Docket No. 217 - Development and Management Plan Inspection

Northeast Utilities Service Company Certificate of Environmental Compatibility and Public Need for the construction of a 345-kV electric transmission line and reconstruction of an existing 115-kV electric transmission line between Connecticut Light and Power Company's Plumtree Substation in Bethel, through the towns of Redding, Weston, and Wilton, and to the Norwalk Substation in Norwalk, Connecticut.

Date: June 29, 2005

Location: _115 kV Underground Route

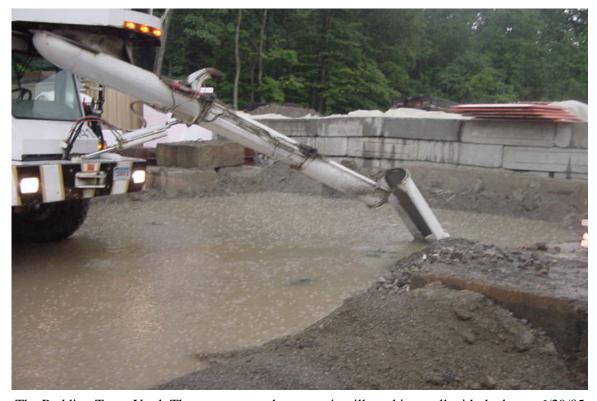
Concrete being poured in ductwork trench along Gallows Hill Road. 6/29/05
